ADDENDUM NO. 1
TO THE
DRAWINGS AND SPECIFICATIONS
FOR THE
17TH Street Reconstruction

Issued From: The City of Bloomington
Planning and Transportation Department
Post Office Box 100
401 North Morton Street, Suite #130
Bloomington, Indiana 47402

Issue Date: January 24th, 2019

SCALE	BRIDGE FILE
1" = 20'	N/A
VERTICAL SCALE	DESIGNATION
1" = 10'	N/A
SURVEY BOOK	SHEETS
N/A	18 of 100
CONTRACT	PROJECT
N/A	17TH STREET RECONSTRUCTION

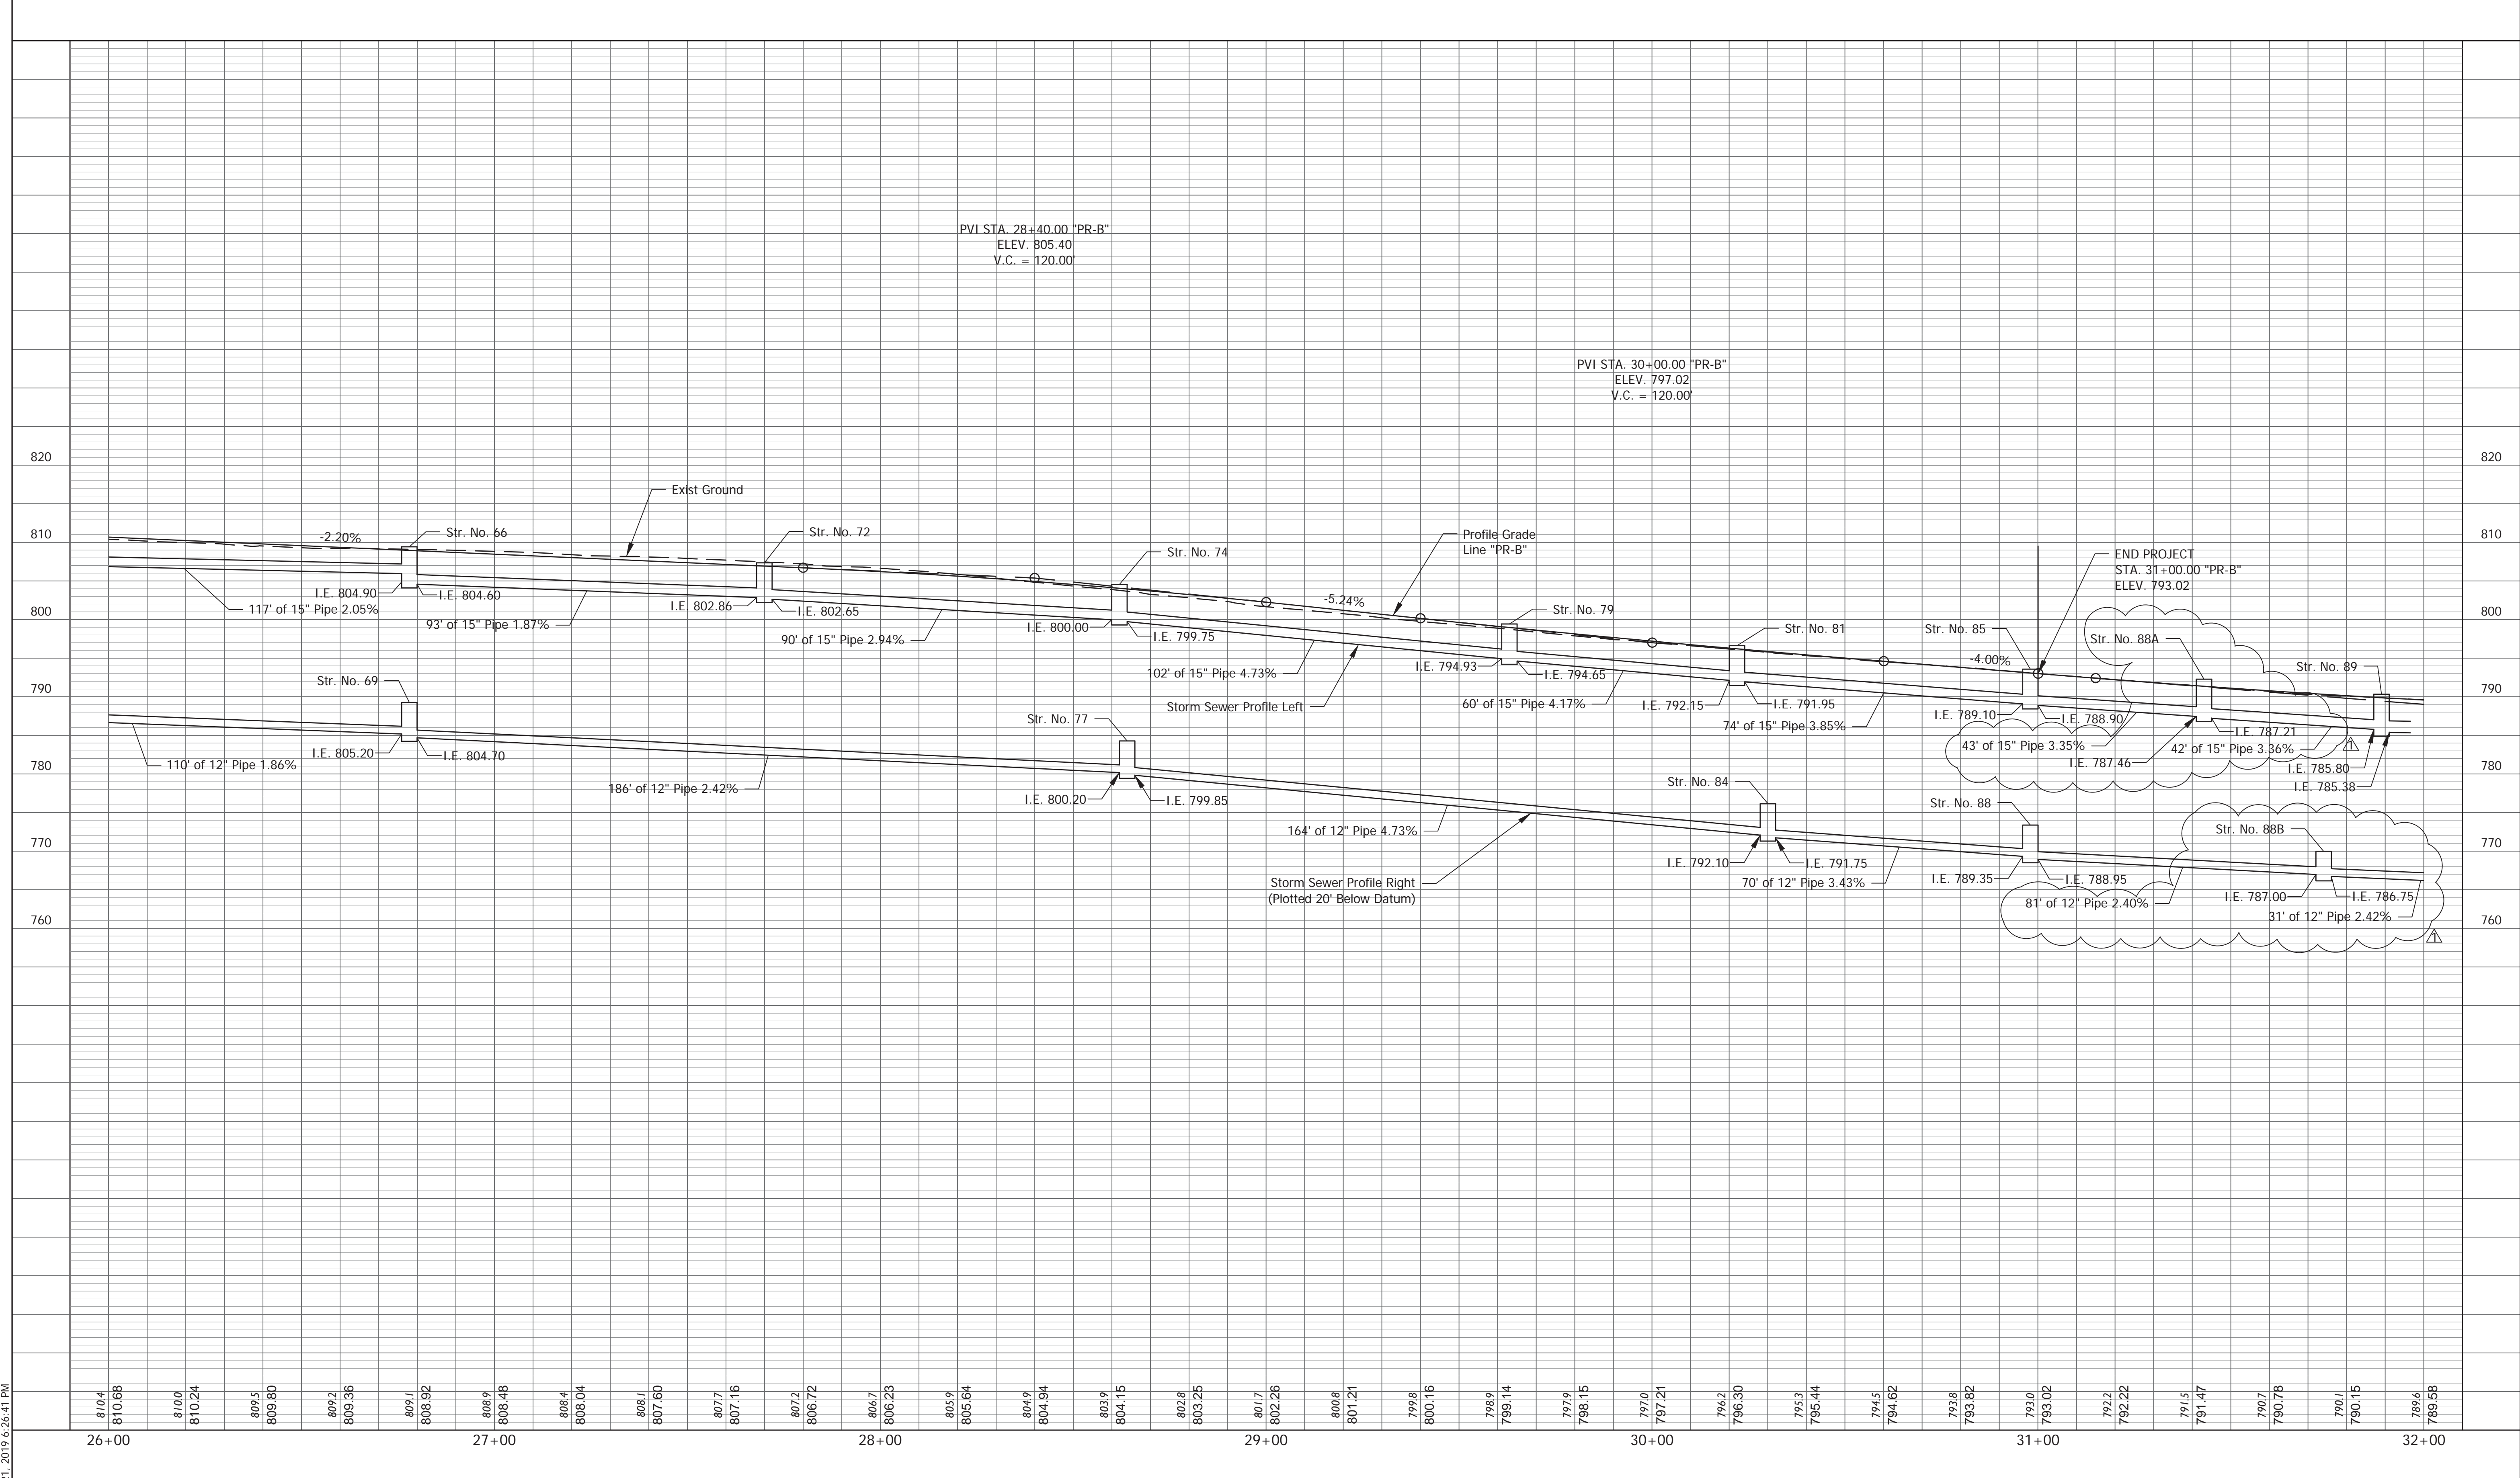
The Plan and Profile Details, sheets 17 & 18, and the Structure Data Table, Sheet 77, have been revised to add separate structures for the Aqua-Swirl structures at the east end of the project. Revised plan sheets and a revised "Proposal Schedule of Items" have been added per this addendum.

(Q) Some of the aqua-swirls are shown with more than one inlet. After talking with manufacturer this cannot be accomplished, there should be one inlet and one outlet?

(A) The Plan and Profile Details, sheets 17 & 18, and the Structure Data Table, Sheet 77, have been revised to add separate structures for the Aqua-Swirl structures at the east end of the project. Revised plan sheets and a revised "Proposal Schedule of Items" have been added per this addendum.

RELOCATED SIGN FOUNDATION

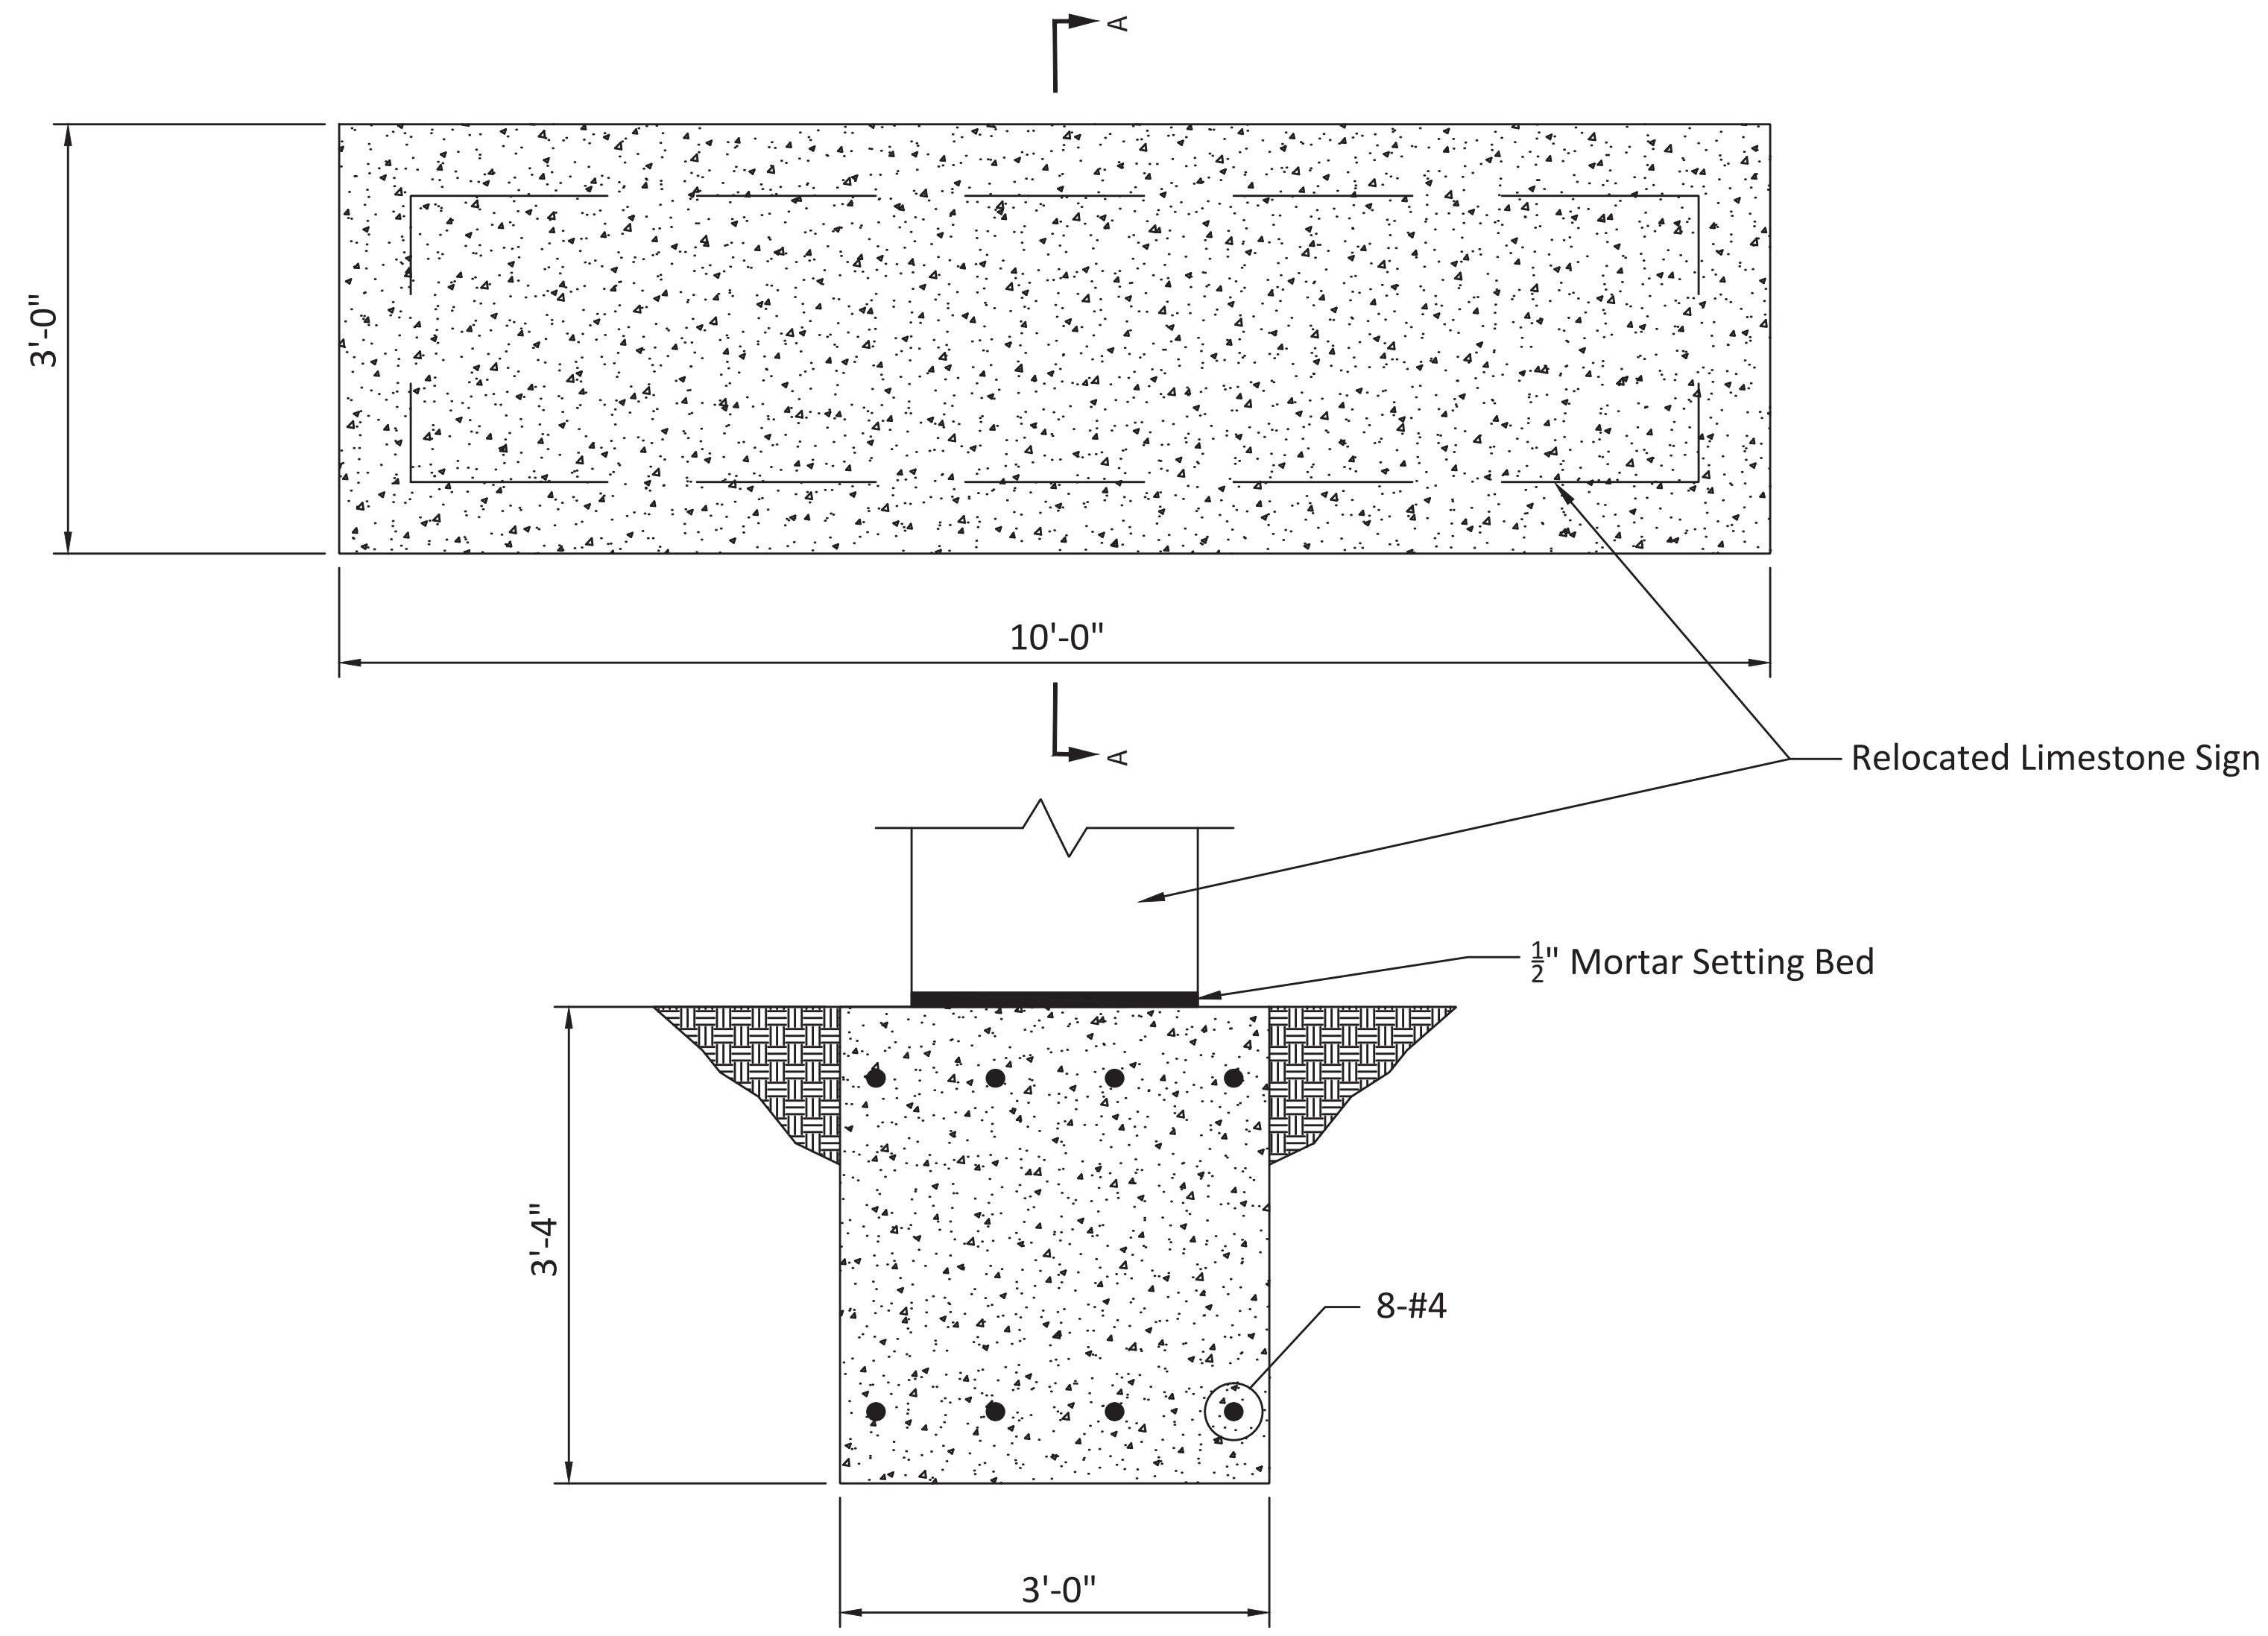
The "Relocated Sign" referenced on the Landscape Details, plan sheet 59, is to be relocated from its current location at 1319 N Crescent Rd. Bloomington, IN 47404. The sign is a solid limestone block that is 9' long x 2' wide x 4'-8" tall with an approximate weight of 6.5 tons. The sign shall be placed upon a sign foundation that is detailed on plan sheet 41-1, which is attached to this Addendum. The sign shall be oriented as shown on the plans with the sign lettering facing westbound traffic.

Payment for "Relocate Neighborhood Sign" shall be at the contract unit price per lump sum, which shall include all labor, materials, equipment, excavation and any incidentals required for the sign foundation and sign relocation. Plan sheet 41-1 and a revised "Proposal Schedule of Items" have been added per this addendum.

SCALE	BRIDGE FILE
1"=40'	N/A
	DESIGNATION
	N/A
SURVEY BOOK	SHEETS
N/A	42 of 100
CONTRACT	PROJECT
N/A	17TH STREET RECONSTRUCTION

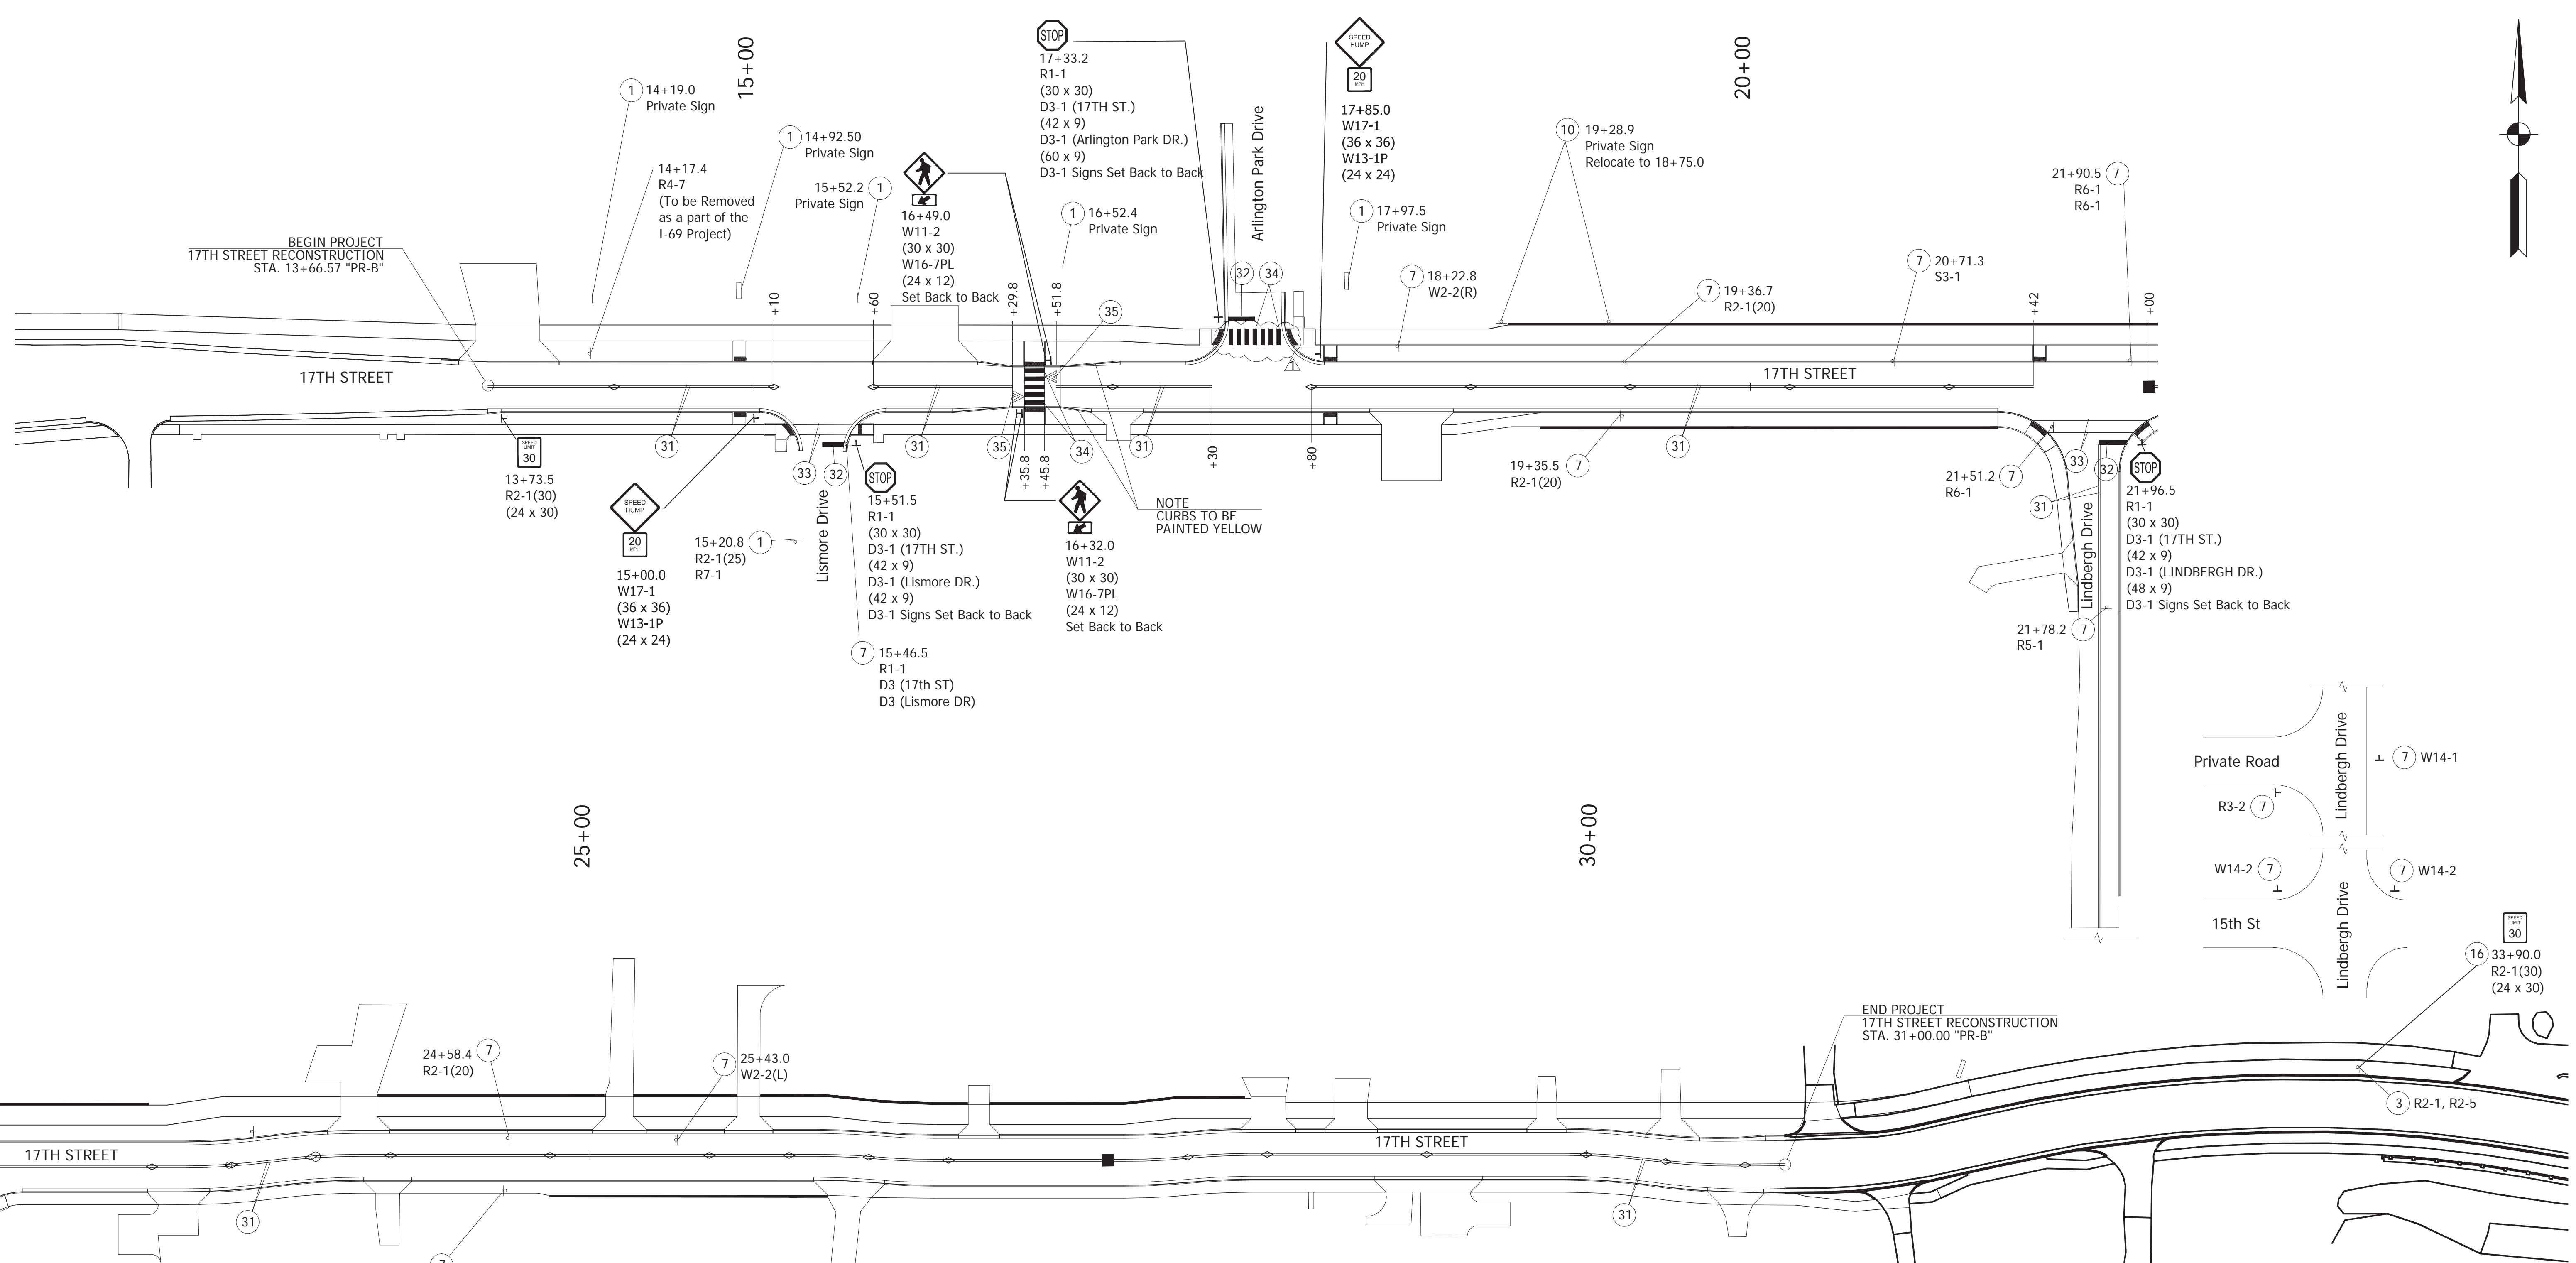
The Pavement Marking & Signing Details, sheets 42 and 75, have been revised to call out 24 inch Crosswalk lines at Arlington Park Drive. Revised plan sheets 42 & 75 and a revised "Proposal Schedule of Items" have been added per this addendum.
